**CITY OF EDGEWOOD  
RECORD PLAT REVIEW CHECK SHEET**

**NAME OF PLAT: Samolly Park**  
**DATE REVIEWED: April 6, 2022**  
**REVIEWED BY: Randall L. Roberts, RLS**

# SAMOLLY PARK

A REPLAT OF LOT 14 AND LOT 15, BLOCK A, OAK LYNN SECOND PLAT, ACCORDING TO THE PLAT THEREOF AS RECORDED IN PLAT BOOK W, PAGE 97, PUBLIC RECORDS OF ORANGE COUNTY, FLORIDA.  
LYING IN  
SECTION 13, TOWNSHIP 23 SOUTH, RANGE 29 EAST  
CITY OF EDGEWOOD, ORANGE COUNTY, FLORIDA

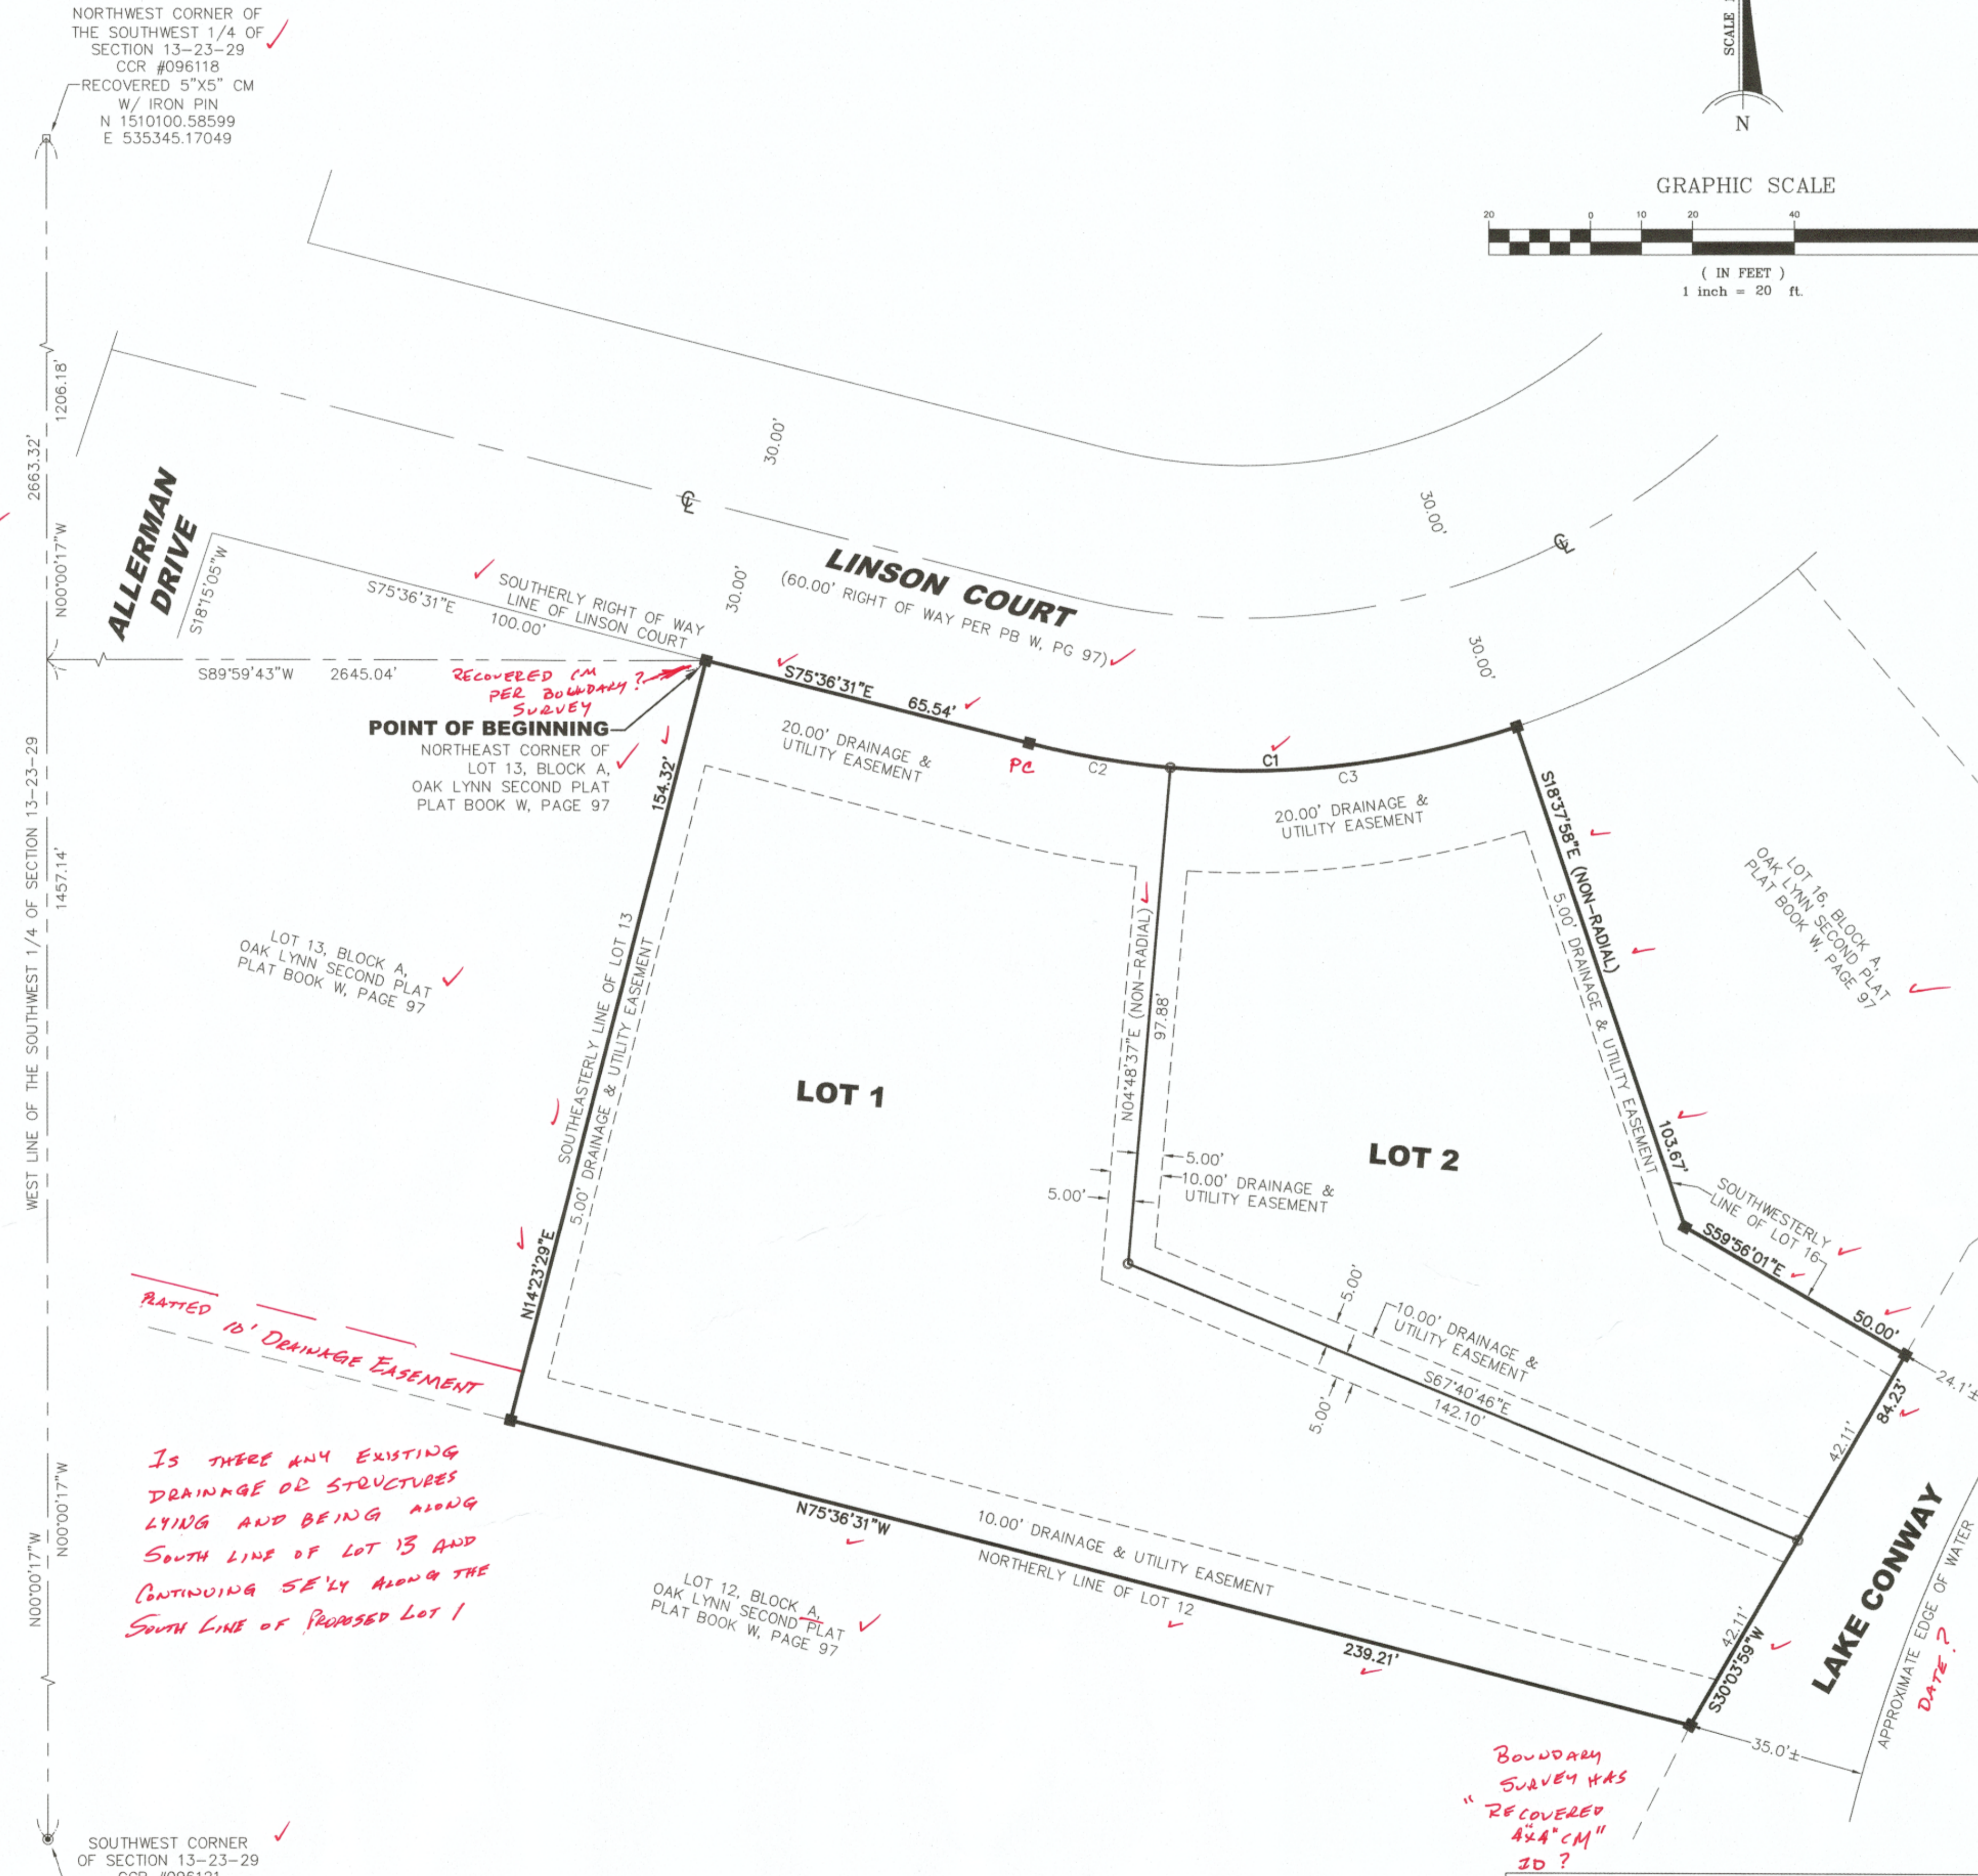
APPROVED Question as to Lot 13 use of Drainage Easement (see pdf)  
 FAILED –

*Is there any existing drainage or structures lying and being along south line of Lot 13 and continuing SE'ly along the south line of proposed Lot 1*

BOUNDARY SURVEY

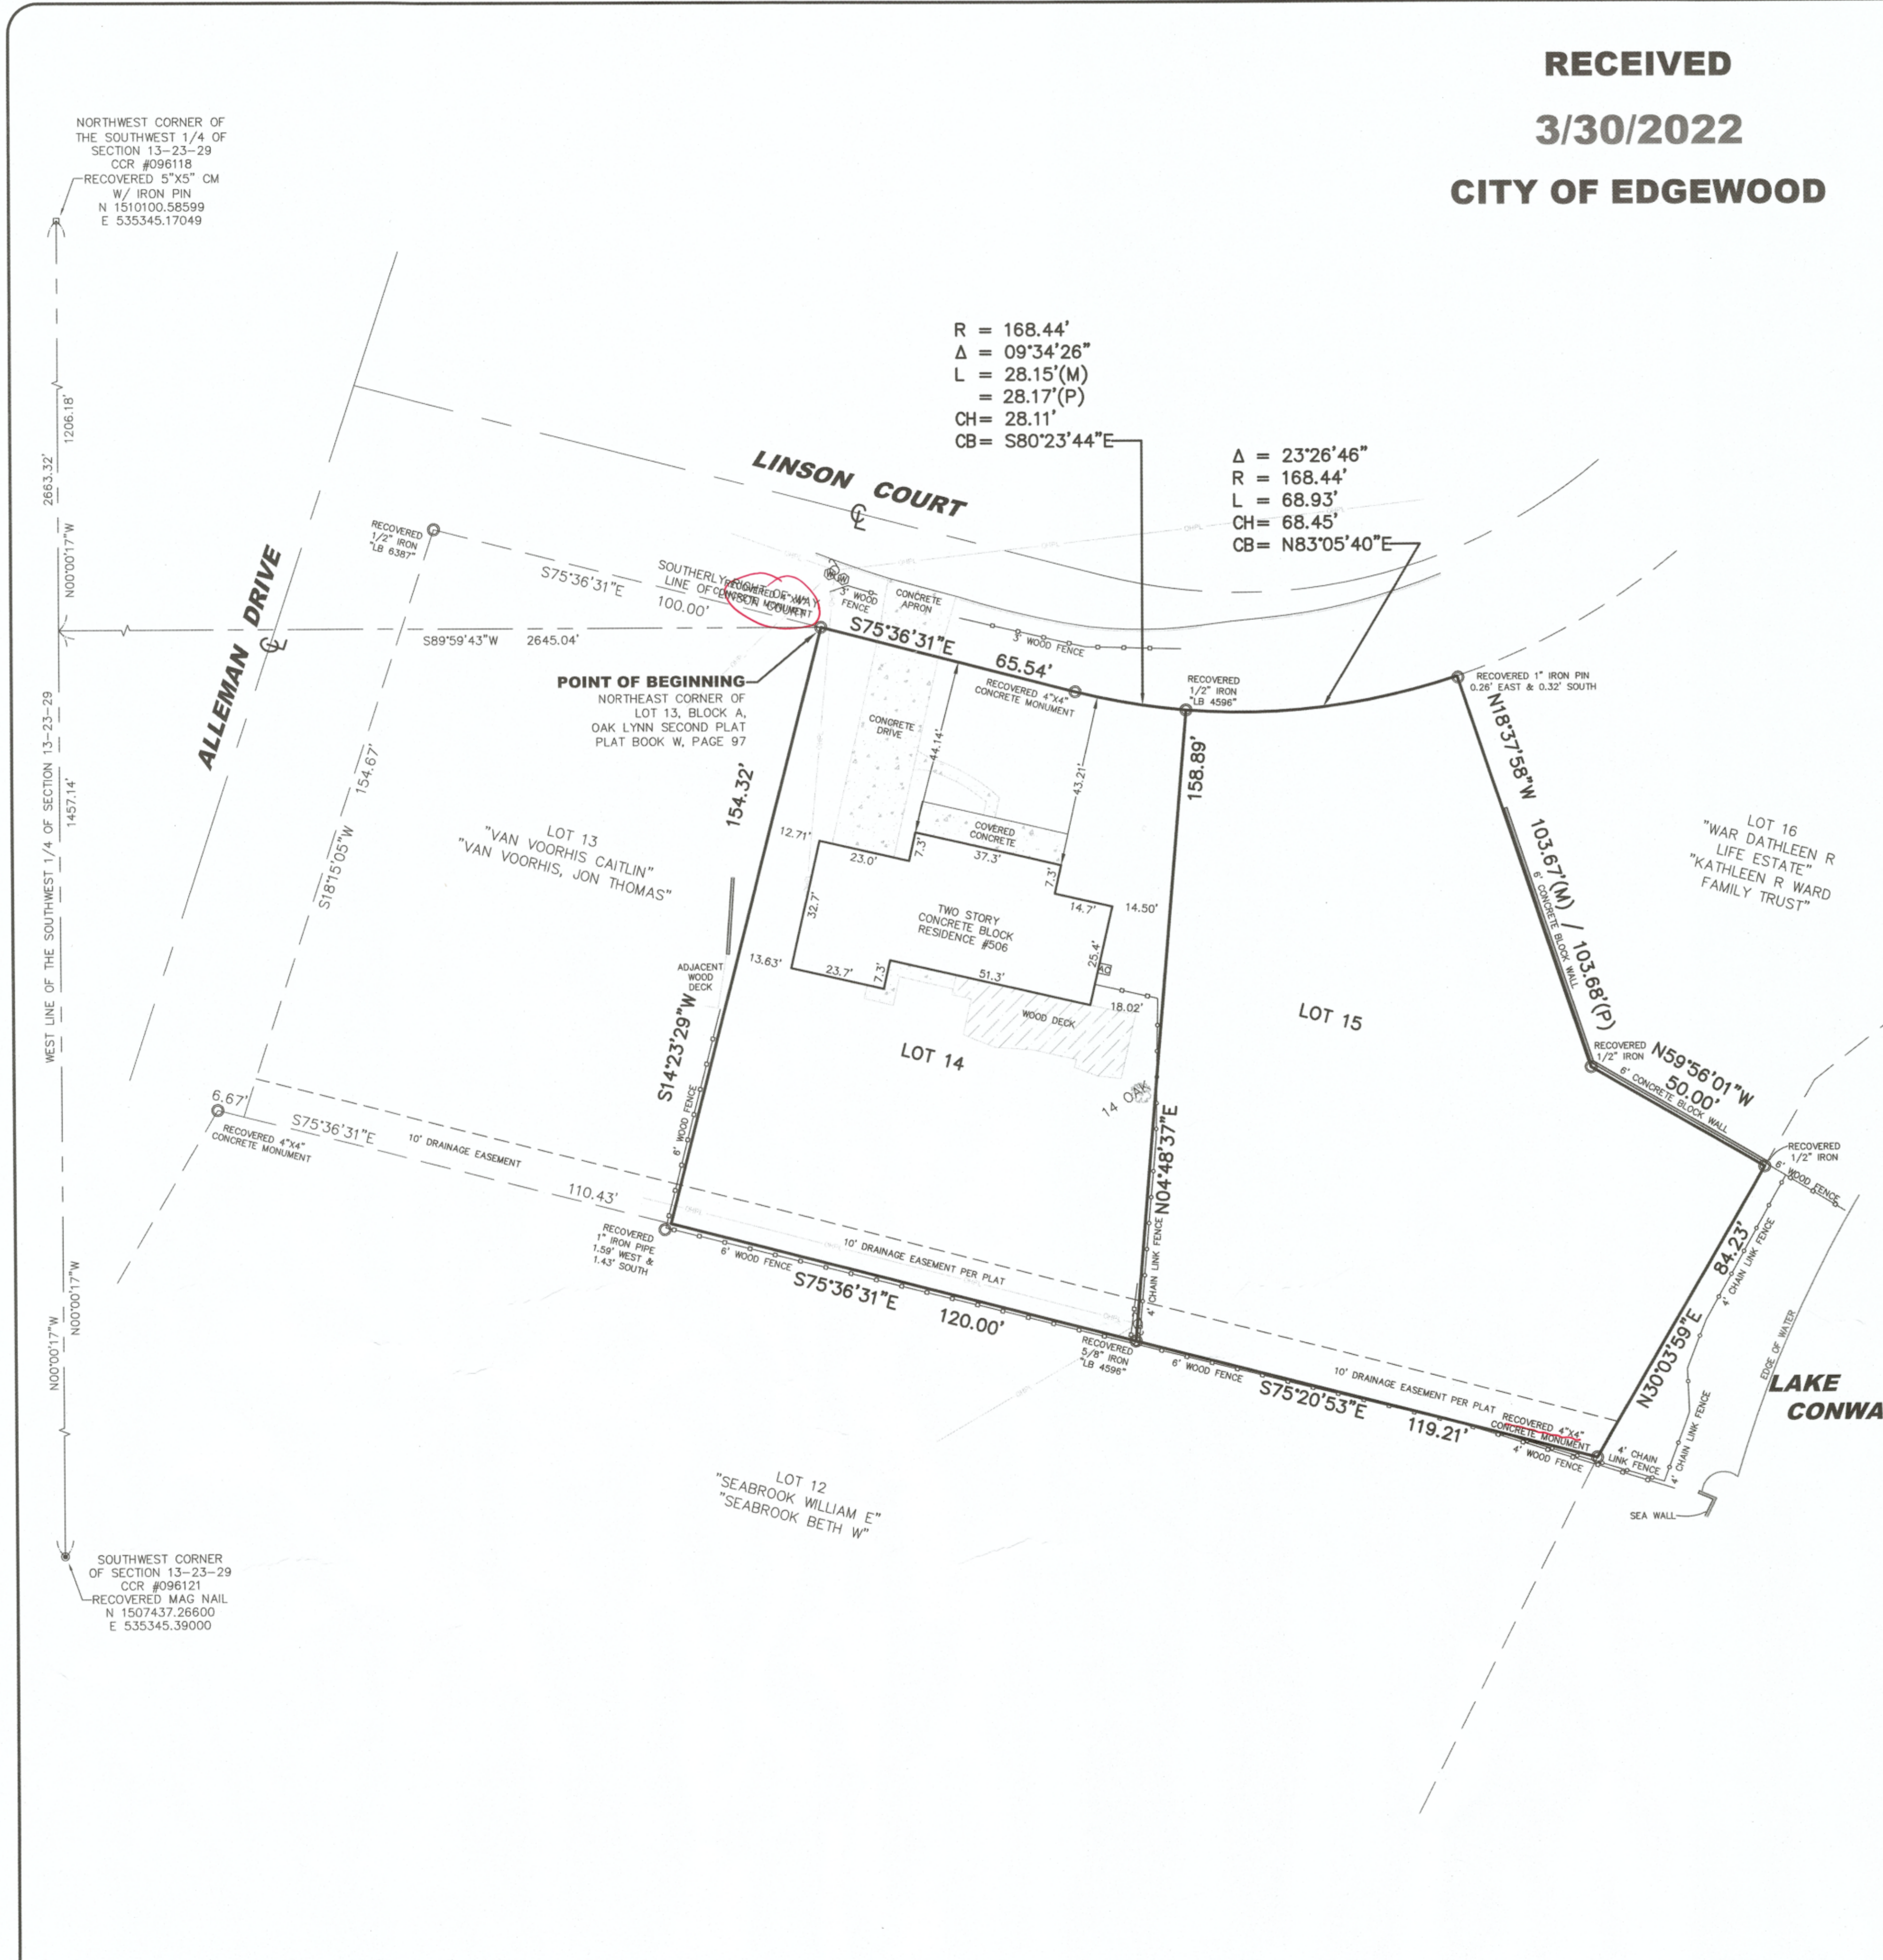
*BOUNDARY SURVEY HAS "RECOVERED 4"x4" CM" ID?*
